# Access Compliance Report

## Public Rights-of-Way

Intersection ID: 14714	Main Street: E_MOREHEAD_ST	Cross Street: HARDING_PL	Location: S
ADA ID: 293611700B79	Ramp Type: Perp	Initial Pass/Fail: Fail	Overall Compliance: No
Severity Score: 12.5			
Codes/Mitigation Info/Possible Solution		Field Measurements/Component Compliance

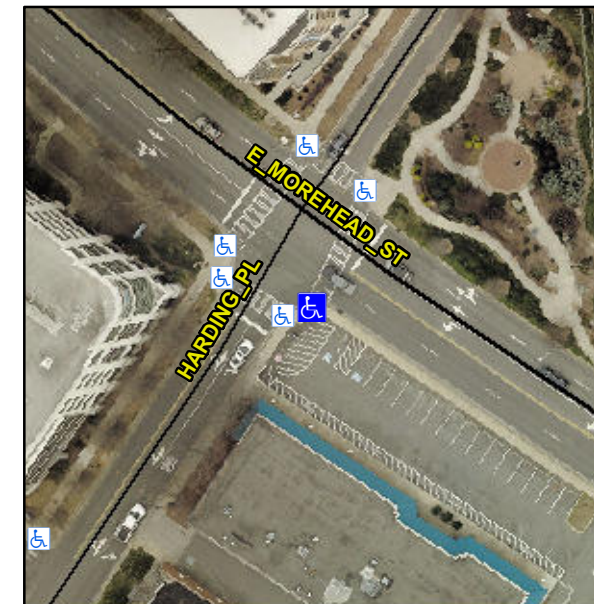
**Not Found, R304.2.2**

Compliance	Description	Data	Compliance	Description	Data
N/A	Ramp Length (in)	36.0	No	Ramp Slope (%)	9.7
Yes	Ramp Width (in)	48.0	Yes	Ramp XSlope (%)	0.5
N/A	Flare Type LT	N/A	N/A	Flare Type RT	N/A
N/A	Flare Slope LT (%)	N/A	N/A	Flare Slope RT (%)	N/A
N/A	Flare Traversable LT?	N/A	N/A	Flare Traversable RT?	N/A
N/A	Landing Length (in)	N/A	N/A	DWS Provided?	N/A
N/A	Landing Width (in)	N/A	N/A	DWS Contrast?	N/A
N/A	Landing Slope (%)	N/A	N/A	DWS Length (in)	N/A
N/A	Landing X Slope (%)	N/A	N/A	DWS Full Width?	N/A
N/A	Landing Curb? (Y/N)	N/A	N/A	DWS Offset (in)	N/A
N/A	Shared Landing?	N/A			
N/A	Gutter Ponding?	N/A	N/A	Gutter Slope (%)	N/A
N/A	Gutter Lip Ht (in)	N/A	N/A	Gutter X Slope (%)	N/A
N/A	Painted X Walk1?	Yes	N/A	Painted X Walk2?	N/A
	X Walk 1 Direction	To NE		X Walk 2 Direction	N/A
N/A	X Walk 1 Width (in)	111.0	N/A	X Walk 2 Width (in)	N/A
	X Walk 1 Slope (%)	1.1		X Walk 2 Slope (%)	N/A
	X Walk 1 X Slope (%)	2.9		X Walk 2 X Slope (%)	N/A

**Remove & Replace Entire Ramp.**
